RECORD DRAWINGS:

REVISED FOR CONSTRUCTION

CULVERT NO. 1 PLAN & PROFILE
REPLAT OF LOVE'S ADDITION NO. 1
CITY OF ROCKWALL
ROCKWALL COUNTY, TEXAS

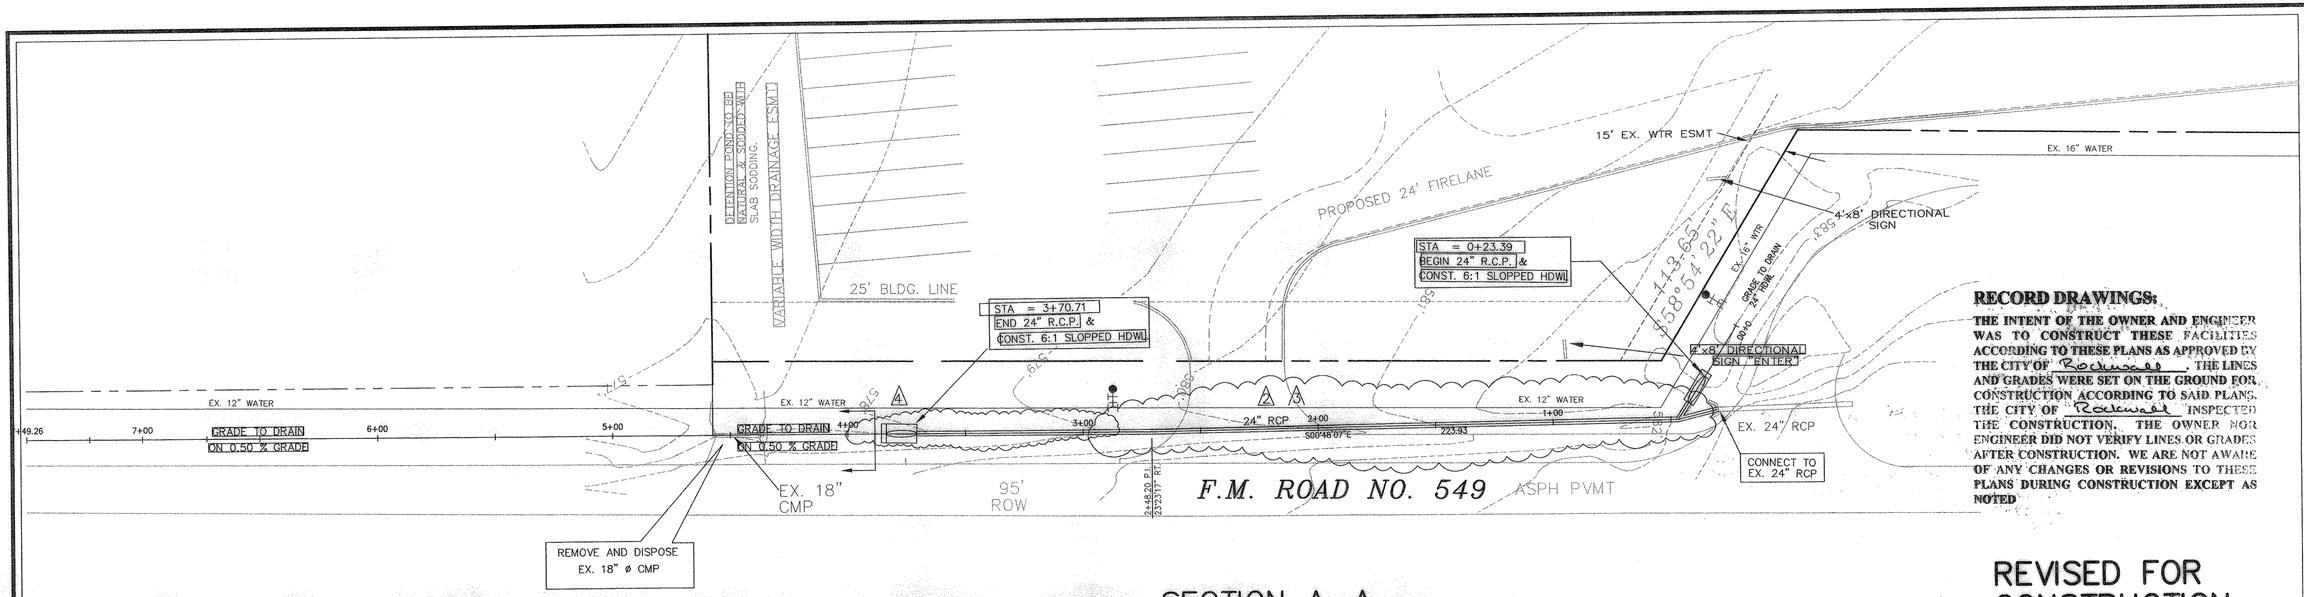
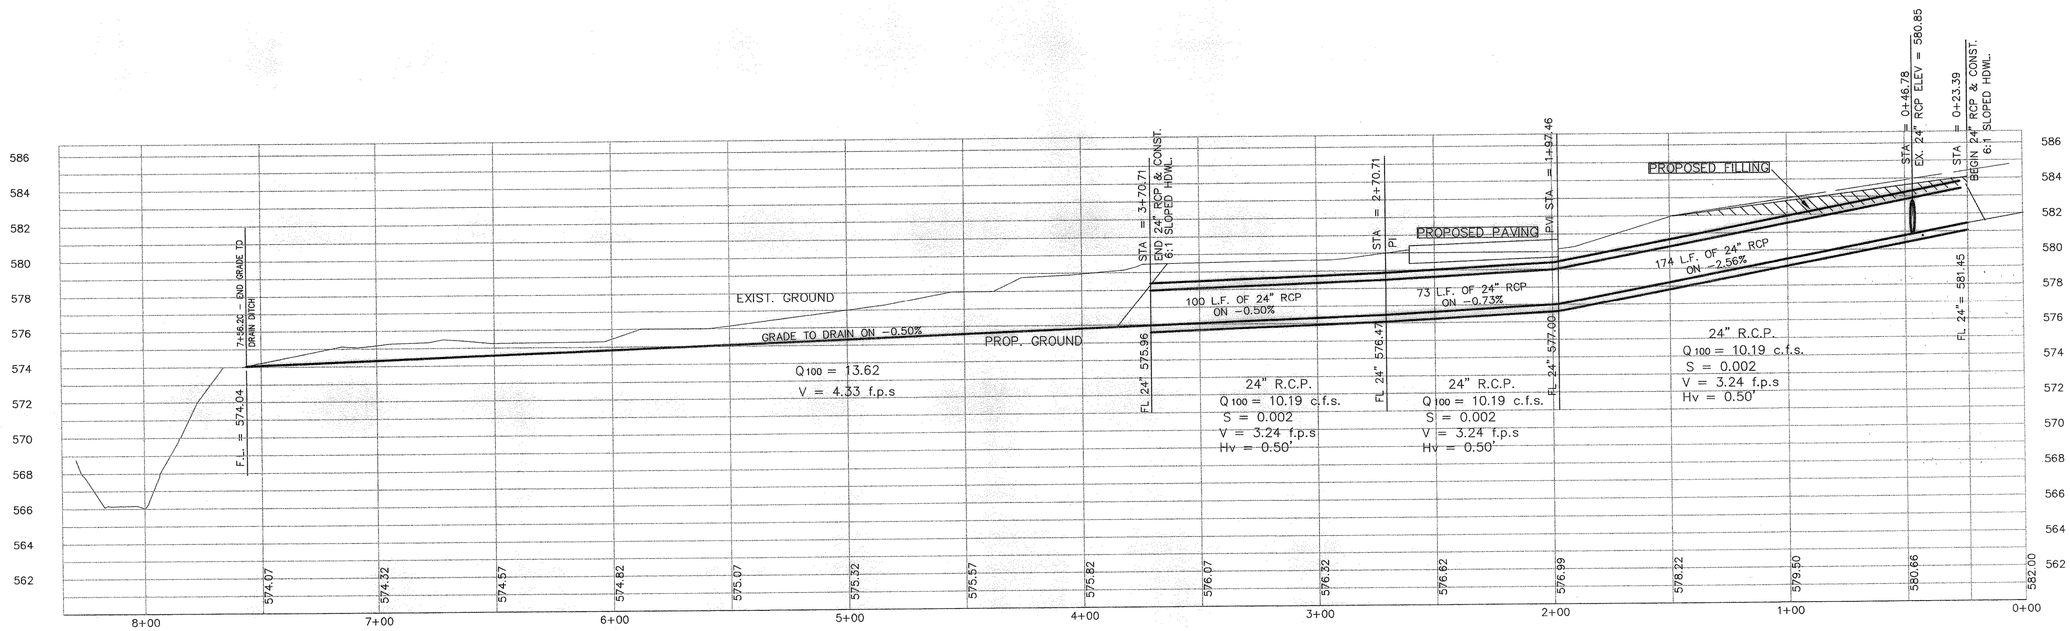
1. CHANGED ALIGNMENT OF 21" R.C.P. CULVERT TO CLEAR EXIST. 12" WATER LINE & EXTEND GRADE TO DRAIN TO EXIST. TOP OF BANK OF CREEK. REV. 12/13/00
2. CHANGED ALIGNMENT OF 21" R.C.P. CULVERT TO 24" RCP AND CONNECT TO EXIST. 24" . OMIT DROP INLET AND LATERAL. REV. 5/09/01
3. LENGTHED 24" RCP TO ACCOMODATE PROPER SIDE SLOPES FOR THE DRAINAGE DITCH. REV. 6/04/01
